Discussion

Investigation of an Electrohydraulic Servo-valve With Tuneable Return Pressure and Drain Orifice¹

Fig. 16 Single block new servo-valve configuration

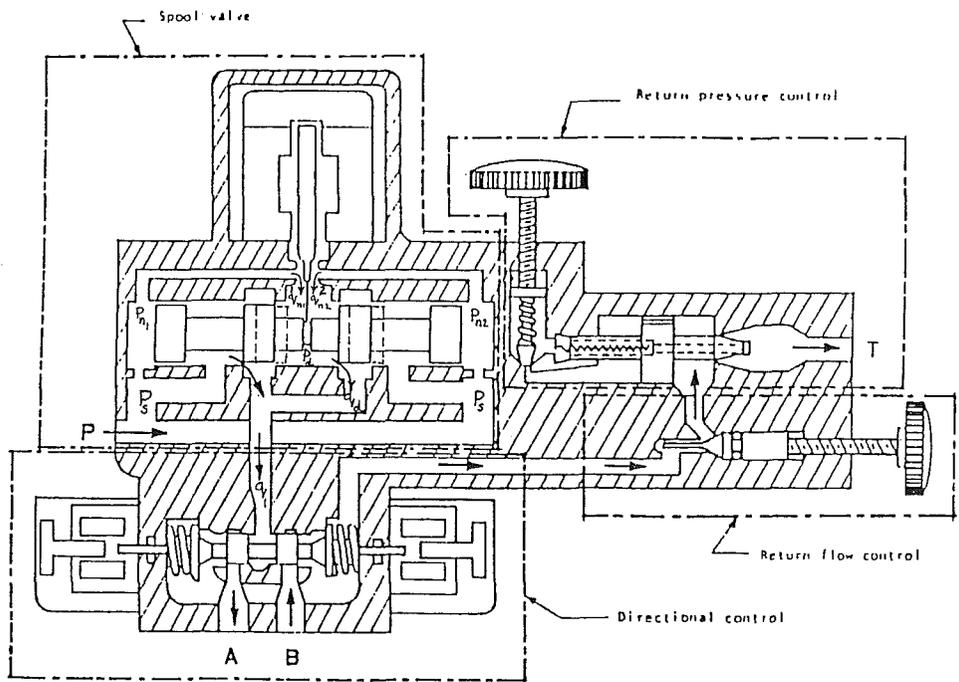
Hussein El-Gammal.² 1. In developing the equations of the system, equation (1) gives the flow rate to the actuator as:

This expression overlooks the flow rate through the flapper nozzles. In the attached diagram, which is an enlarged copy of Fig. 16, for a flapper deflection resulting in the spool position shown in a broken line, the flow rate to the actuator should be:

It seems to me that the inclusion of q_d in the analysis is necessary. The effects resulting from this on the transient response parameters (over shoot, settling time, and steady state speed) should in my opinion be investigated.

1. The flapper-nozzles flow rate q_d mentioned in the discussion is normally referred to as "internal leakage" by servovalve manufacturer.

This leakage is generally maximum at the valve null, called "null leakage." The servovalve used in our experimental setup is Moog, model 760-103 which has a rated flow of 10 gpm with 1,000 psi supply pressure. The maximum internal leakage specified by the manufacturer is 0.17 gpm which represents less than 2 percent of the nominal rated flow. Therefore, the fact that q_d is not considered in our analysis seems very realistic.
